Product Bulletin # TDS-280 Rev 1

Top Drive PLC Panel Brackets

Figure 2: Bracket options

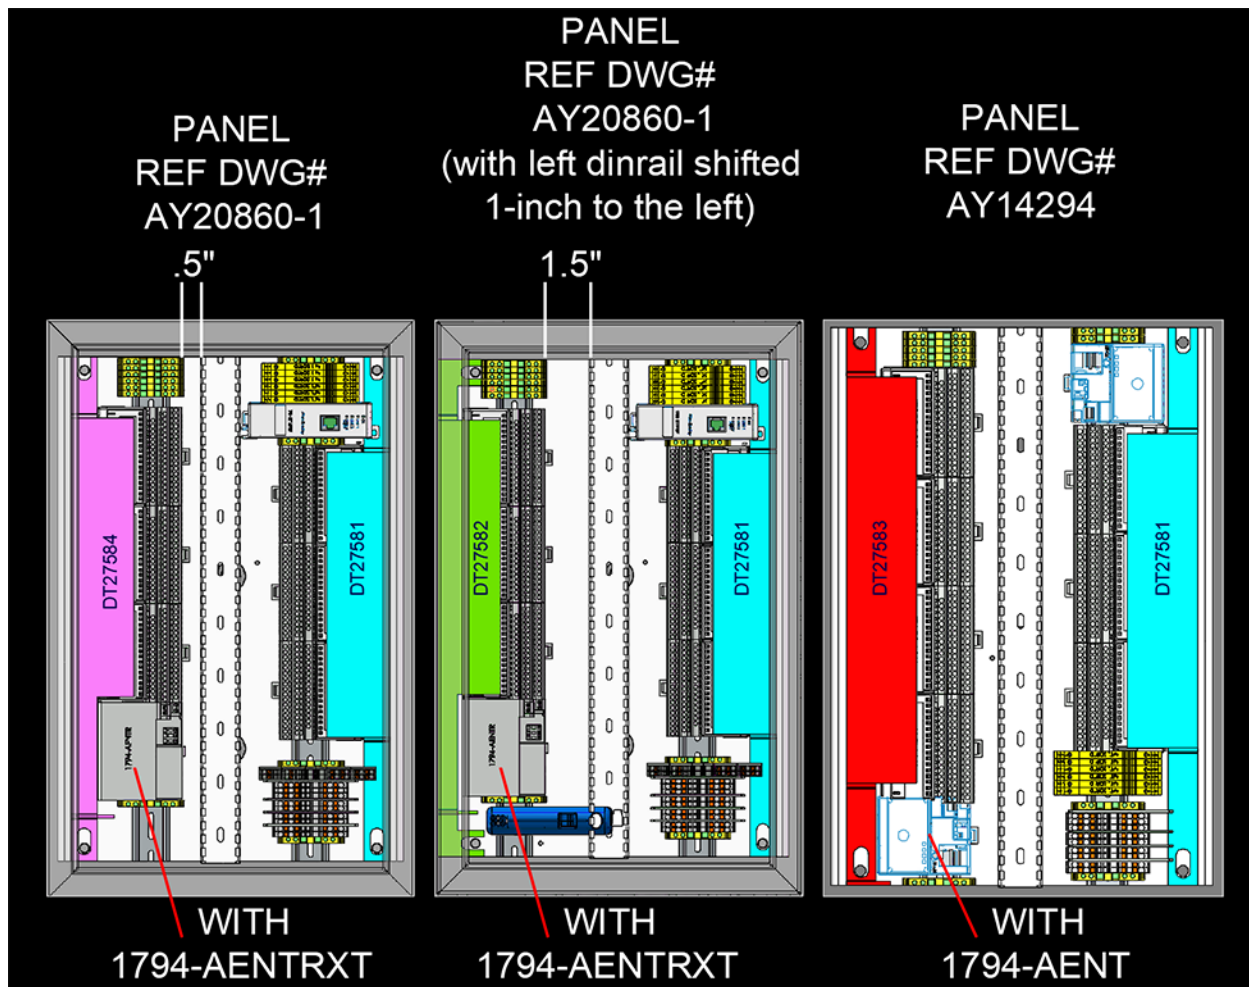
1. If you have FLEX I/O Adapter model 1794-AENT, continue to "Bracket Selection" on page 3.
2. If you have FLEX I/O Adapter model 1794-AENTRXT, there are two options. The difference between these two options is the distance from the edge of the terminal block (mounted on the leftmost DIN rail) to the cable duct (see Figure 2 as reference).
3. Remove power from the enclosure and measure the distance from the edge of the terminal block to the cable duct as indicated in Figure 2 on page 2.
4. Continue to "Bracket Selection" on page 3.

- From Table 1, select two brackets (left and right) corresponding to your AENTR module and distance from the edge of terminal block to the cable duct. Refer to Figure 2 on page 2 for details.

Figure 4: Bracket P/N: DT27581 with gasket installed

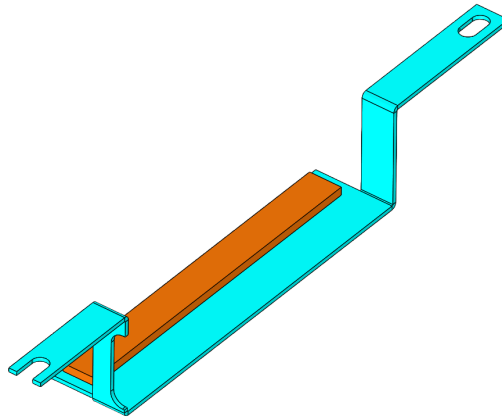
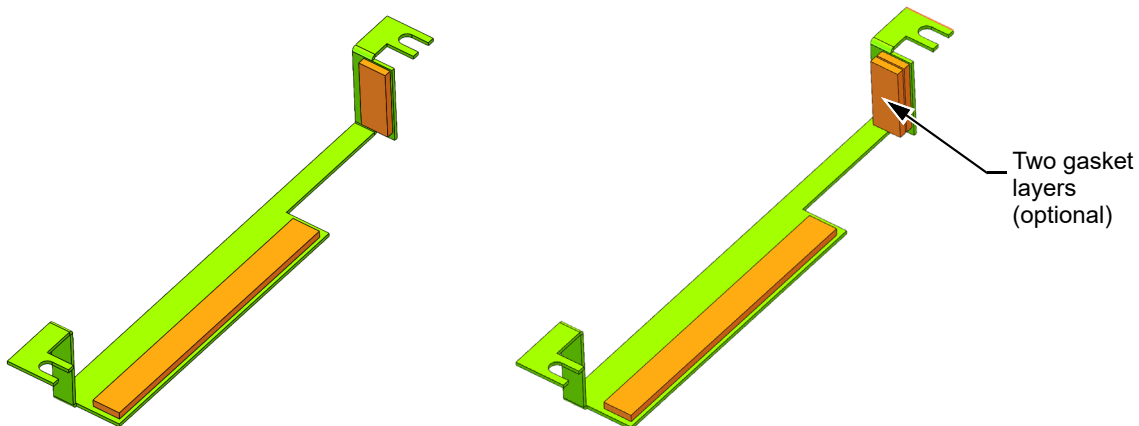
1. Cut the gasket (P/N: S10076) to the appropriate sizes as indicated below.
2. Remove the liner to expose the adhesive surface and attach the gasket(s) to the bracket as indicated below

Figure 8: Brackets installed

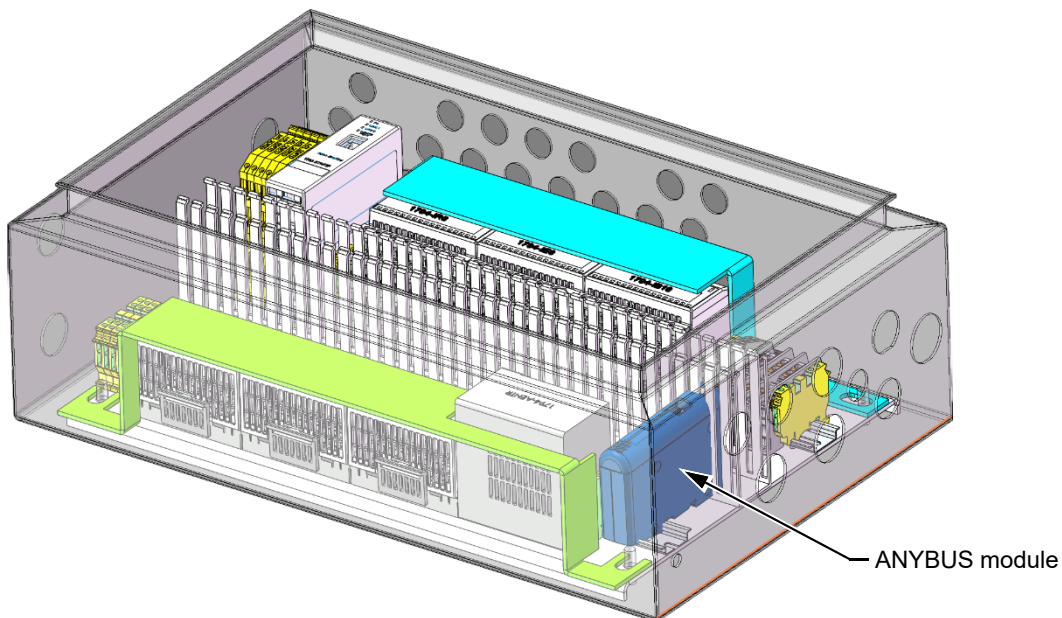
If an ANYBUS module is present, remove it from the DIN rail and relocate it adjacent to the wire duct or secure it in an available space next to the duct. Refer to Figure 8.

4. Tighten the bolts once the bracket is in place. See Figure 8 for reference.
5. Repeat Steps 2 through 4 for the second bracket.
6. Restore power to the panel.
